ADDENDUM NO. 01
TO
SPECIFICATIONS AND CONTRACT DOCUMENTS
FOR
TMT – RESURFACE LEASED AREA, CENTER ROAD ASPHALT REPAIRS
JPA CONTRACT NO. MC-1673C

The item(s) of this Addendum shall modify and become a part of the contractual documents for this project as of this date. (Failure to acknowledge this addendum will be grounds for rejection of proposal.)

PROJECT DESCRIPTION
TALLEYRAND MARINE TERMINAL CENTER ROAD - PHASE I - 2" MILL & 3" ASPHALT PAVING DETAILS

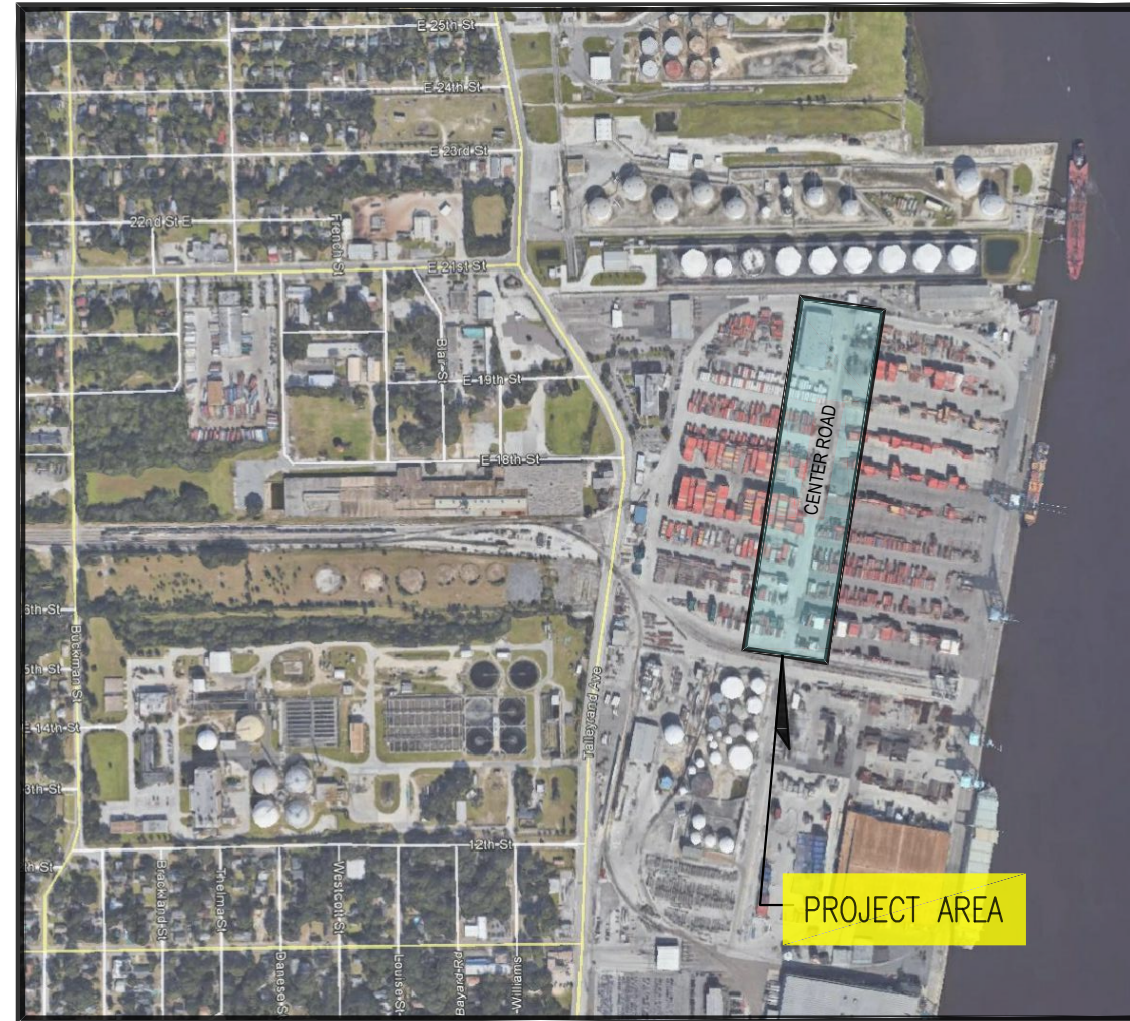
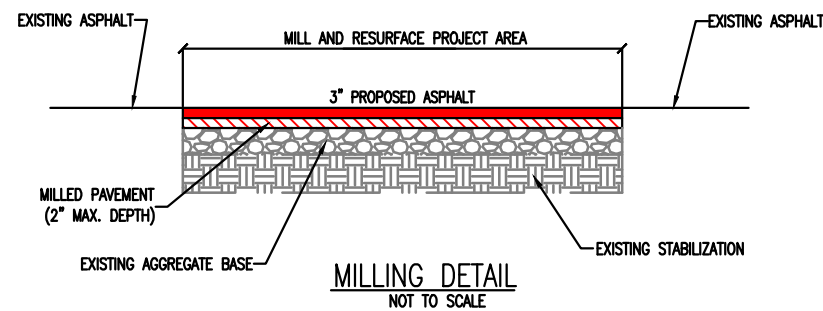
“REVISED” Drawings, Sheets 1 & 2

- A. **Area 1:** Area 1 is approximately 415 SY (78' long x 48' width), and is on the roadway. Milling and asphalt overlay shall be extended at least to the width of the roadway. The Contractor shall mill an average of 2", including area around Electrical Manhole # 2 (see drawings). The new final asphalt layer to be installed is estimated to range between 2" and 3" of thickness to achieve an acceptable sloped surface that will allow run-off water from this area to be directed toward Catch Basin 1 (see drawings). Additional asphalt placement for leveling is anticipated. Final asphalt surface shall be placed in such a way that true positive drainage is achieved. No water ponding is acceptable. This area includes milling and paving around Electrical Manhole # 2 (see drawings). Final asphalt surface shall match elevation of utilities embeds.

- B. **Area 2:** Area 2 is approximately 155 SY (100' long x 14' width), and is out of the roadway, but adjacent to it. The Contractor shall mill an average of 2". The new final asphalt layer to be installed is estimated to range between 2" and 3" of thickness to achieve an acceptable sloped surface that will allow run-off water from this area to be directed toward Catch Basin 4 (see drawings). Final asphalt surface shall be placed in such a way that true positive drainage is achieved. No water ponding is acceptable.

- C. **Area 3:** Area 3 is approximately 75 SY (30' long x 22' width), and is on the roadway, around several water valve jackets. The Contractor shall mill an average of 2" around Water Valves # 3 (see drawings). The Contractor shall remove concrete around water valves jackets and substitute it by asphalt. The new final asphalt layer to be installed is estimated to be 3" of thickness to achieve an acceptable sloped

surface that will allow run-off water from this area to be directed toward Catch Basin 5 (see drawings). Additional asphalt placement for leveling is anticipated. Final asphalt surface shall be placed in such a way that true positive drainage is achieved. No water ponding is acceptable. This area includes milling and paving around Water Valves # 3 (see drawings) which shall be repaired and adjusted (raised) to match final asphalt surface elevation.
